# SONY® Service Bulletin

NO: HIF11-99-029

**SUBJECT:** DIM DISPLAY TUBE

**MODEL (S):** DHC-MDX10, HCD-MDX10

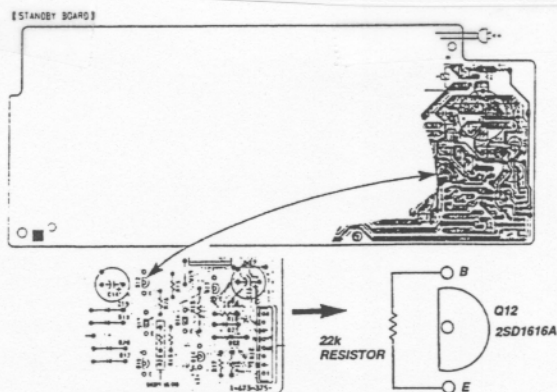
**Symptom:** The customer complains of a dim display.

**Solution:** Perform the following:

1. Replace Q12 "RT1N137L" with **2SD1616A (8-729-142-51)**.
2. Add a 22k 1/4W resistor (**1-249-433-11**) as outlined below.
